**Project: IEEE P802.15 Working Group for Wireless Personal Area Networks (WPANs)**

**Submission Title:** [DS-UWB Responses to MB-OFDM-Voter NO Comments]

**Abstract:** [Response to NO voter comments and feedback regarding the DS-UWB (Merger #2) Proposal]

# Improved Proposal Is Based On 2 Parallel Branches, 3-bit A/D, Symbol Rate Output

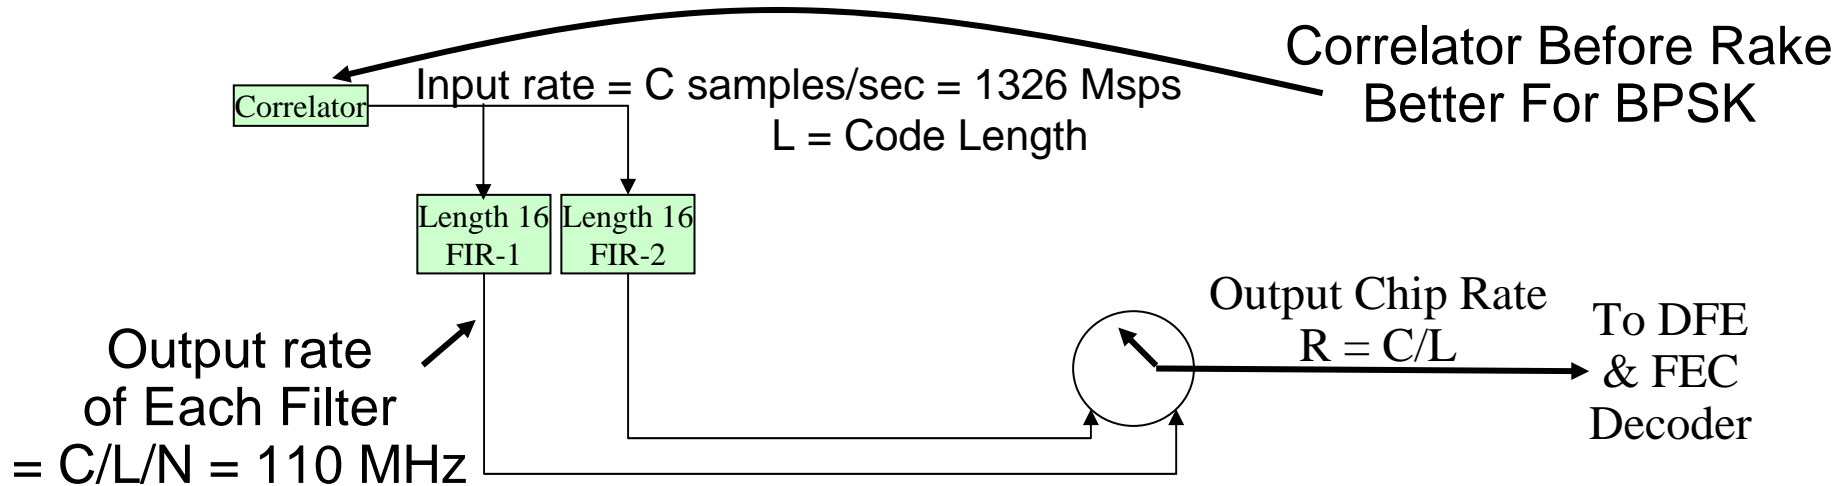
- Gate count reduction is due to
  - Moving of code correlator prior to rake
    - Code correlator (only requires adders) reduces processing rate to symbol rate prior to CMF or rake processing
  - Output rate is L times lower (L= code length)
    - Reduces output rate by the code length
  - Replace 64-BOK with 2-BOK (BPSK)
- A/D Is 3 bits, not 4 bits

Parallel N=2 filters so each can run slower by a factor of 2  
 $1326/L/2 = 1326/6/2 = 110 \text{ MHz}$

Complexity = (16 multipliers) \* (N=2 branches) \* (400 gates per 3-bit mult) \* (110 MHz)

**= 26k Gates (including adders and overhead)**

# Digital RFI Removal

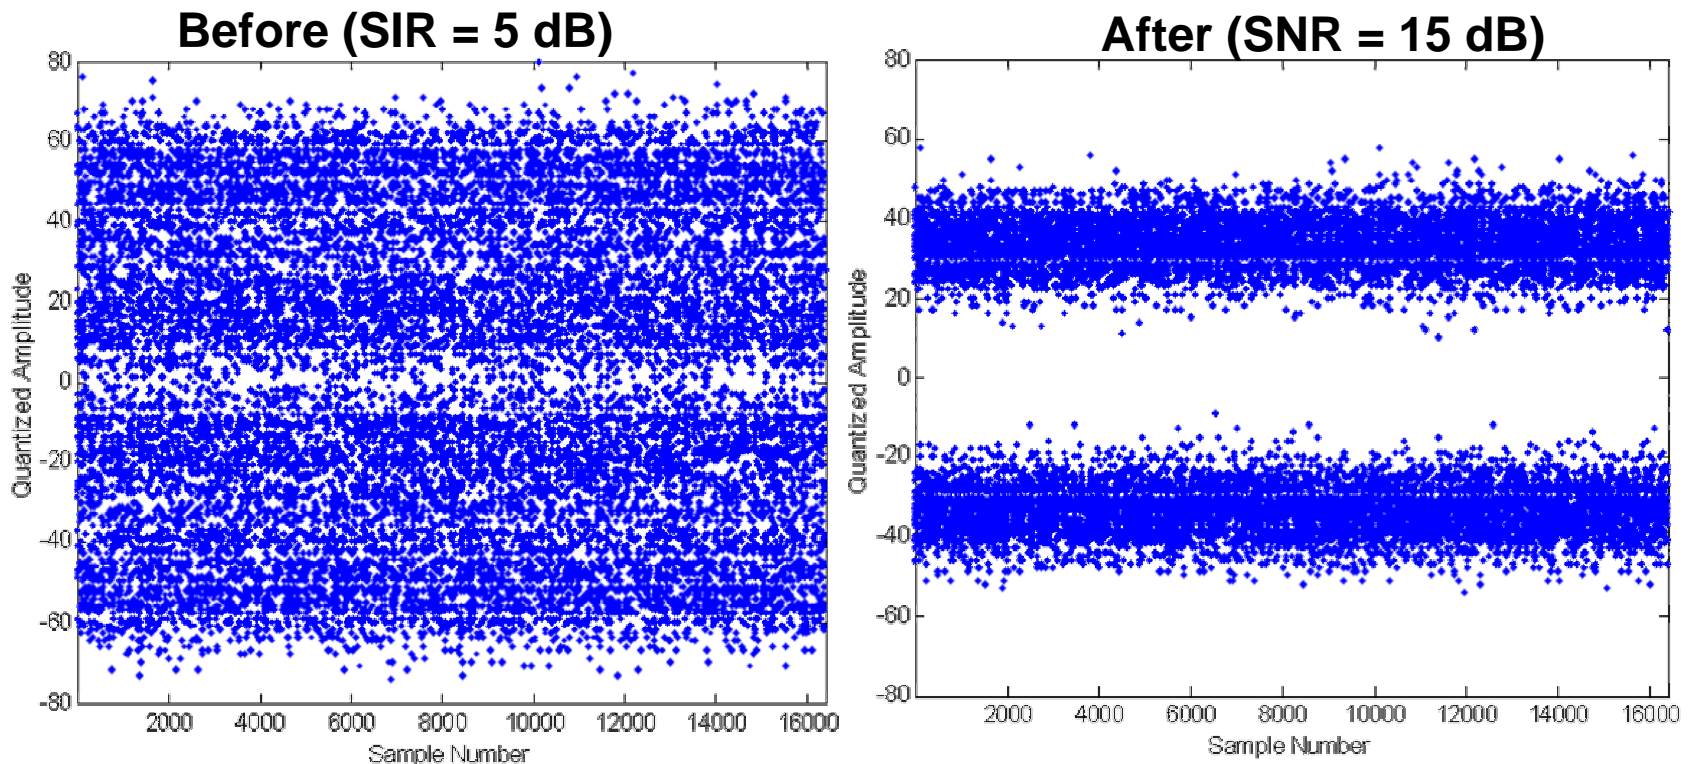
- (c) **Robustness to Narrow-band Interferers:** Document 15-03-0449-03-003a also demonstrates that the MBOK system does not meet the requirements of the selection criteria document in its ability to handle narrow band interferers. It is shown to be about 10 dB worse than the MB-OFDM system. The MBOK proposal claims that narrow-band interference rejection is performed using an external tunable notch filter. Can you provide details on the mechanism to detect a narrow-band interferer, the effectiveness and complexity of the detection circuitry and the loss in performance due to inserting a tunable notch filter at the receiver? Is the insertion loss due to the tunable notch filter also considered for all the other performance results?

- Real signal and noise from hardware
- A/D samples fed into Matlab
- 6 bits used to represent basis functions
- Data processed in 128 sample blocks

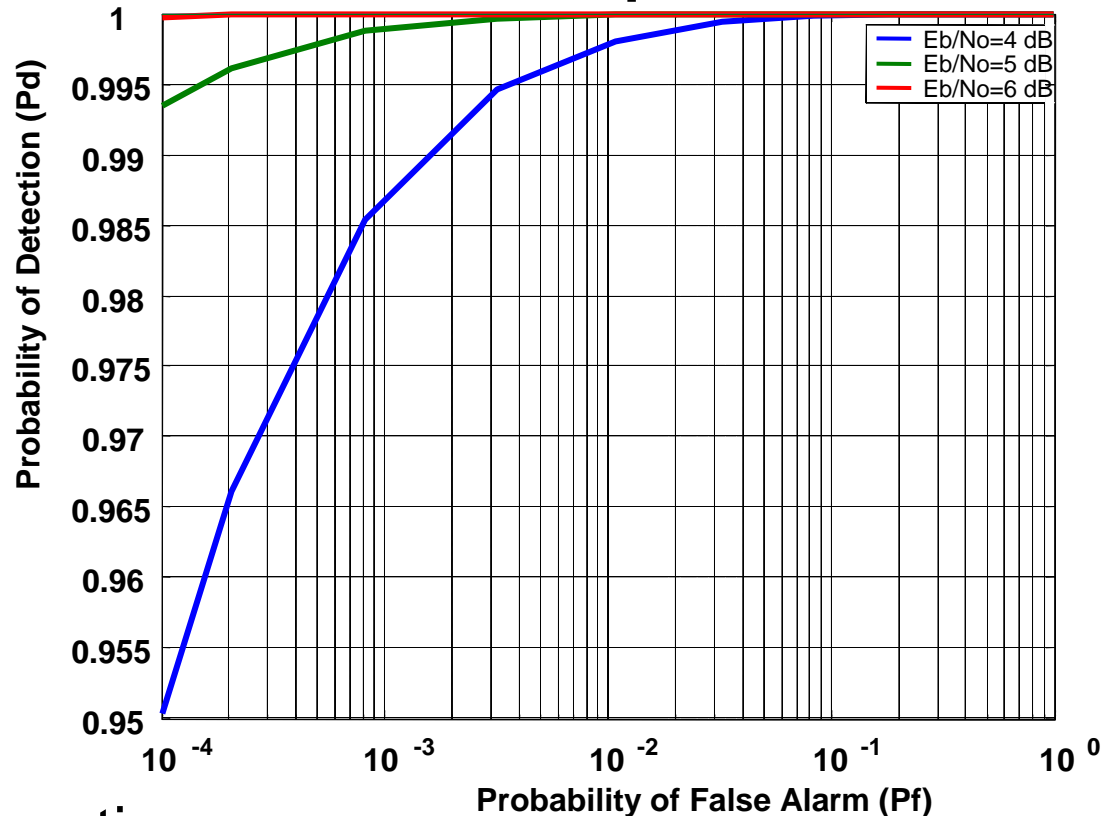
A RS code is used as a concatenated code for data rates of 112 Mbps, 200 Mbps, 224 Mbps and 448 Mbps. The use of a concatenated code results in latency due to the need to receive the entire code word before decoding/de-interleaving and the latency of the decoder operation. For instance, a latency of two code words at a data rate of 112 Mbps corresponds to ~8 microseconds. However, the SIFS time specified in the MBOK proposal is 5 microseconds. How is it possible to meet the SIFS time, if a concatenated code is used?

Reed-Solomon codes are no longer a part of the DS-UWB proposal.
